# Service Manual

## SL-S340

**Note:** • This simplified service manual is provided to indicate the main differences between the original model No. SL-S240 (P) and the subsequent model No. SL-S340 (P, PC).

### CHANGE IN REPLACEMENT PARTS LIST (SL-S240 Service Manual of pages 33~35.)

SCHEMATIC DIAGRAM (SL-S240 Service Manual of page 22.)

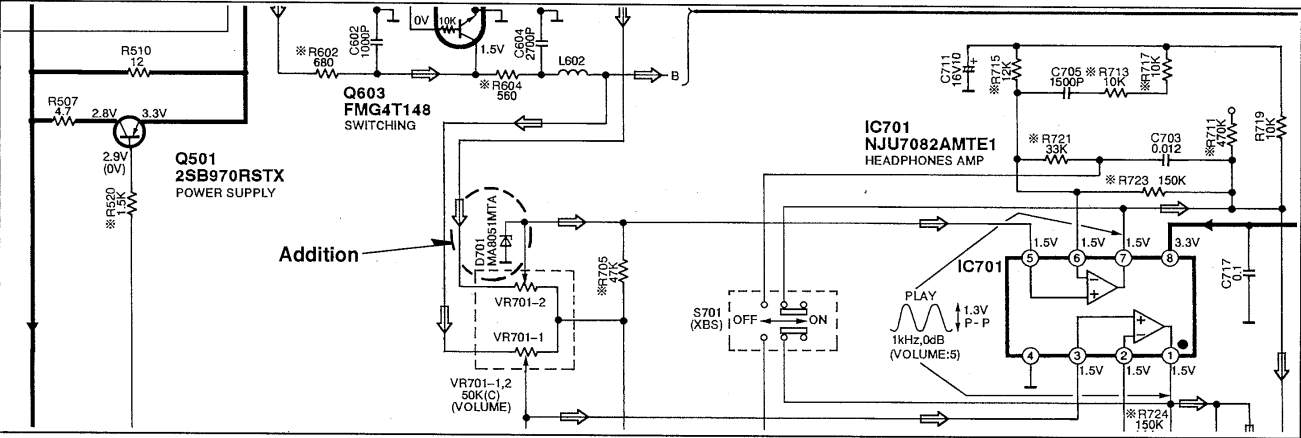
Ref. No.	Change of Part No.		Part Name & Description	Remarks
	SL-S240 (P)	SL-S340 (P, PC)		
INTEGRATED CIRCUIT (S)				
IC503	LH6456K2	MN41440CSJ7T	4M DRAM	
DIODE (S)				
D701	—	MA8051MTX	DIODE	Addition
CHIP JUMPERS				
RJ502	—	ERJ6GEY0R00V	CHIP JUMPER	Addition
CABINET AND CHASSIS				
5	RFKJLS240P-K	RFKJLS340P-K	BOTTOM CABINET ASS'Y	
7	RYF0402A-K	RYF0402D-K	CD COVER ASS'Y	
12	RFKKLS240P-K	RFKKLS340P-K	INTERMEDIATE CABINET ASS'Y

PACKAGING (SL-S240 Service Manual of page 34.)

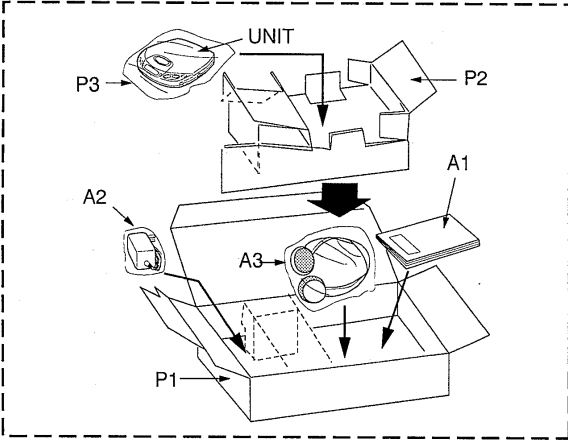
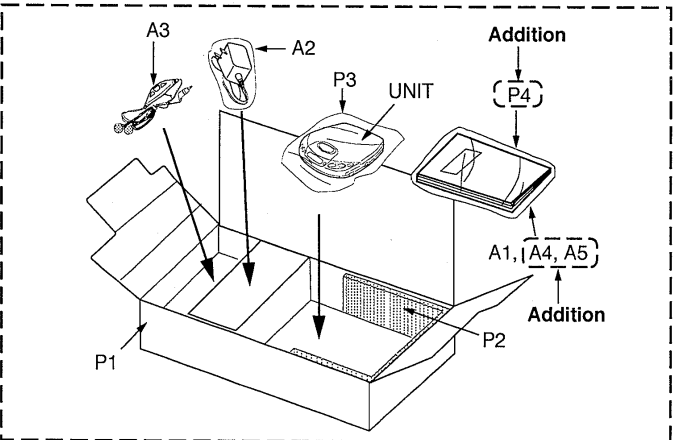
Ref. No.	Change of Part No.		Part Name & Description	Remarks
	SL-S240 (P)	SL-S340 (P, PC)		
PACKING MATERIAL				
P1	RPK0745	RPK0749	PACKING CASE	(P)
		RPK0785	PACKING CASE	(PC)
P2	RPQ0593	RPQ0593	SPACER	(P)
		RPQ0639	SPACER	(PC)
P4	—	—	—	(P)
		RPF0046	PROTECTION BAG (F.B.)	(PC) Addition
ACCESSORIES				
A1	RQT3374-P	RQT3374-P	INSTRUCTION MANUAL	(P) ※1
		RFKSLS240PCK	INSTRUCTION MANUAL ASS'Y	(PC) Addition
A3	RPHT103DPYS1	RPHT103DPYS1	STEREO HEADPHONES	(P)
		RFEV317P-KS	STEREO EARPHONES	(PC)
A4	—	—	—	(P)
A5	—	SQX7185	WARRANTY CARD	(PC) Addition
		—	—	(P)
A6	—	SQX9131	SERVICENTER LIST	(PC) Addition
		—	—	(P)
A6	—	RKB205ZA-0	EAR PADS	(PC) Addition ※2
		—	—	(P)
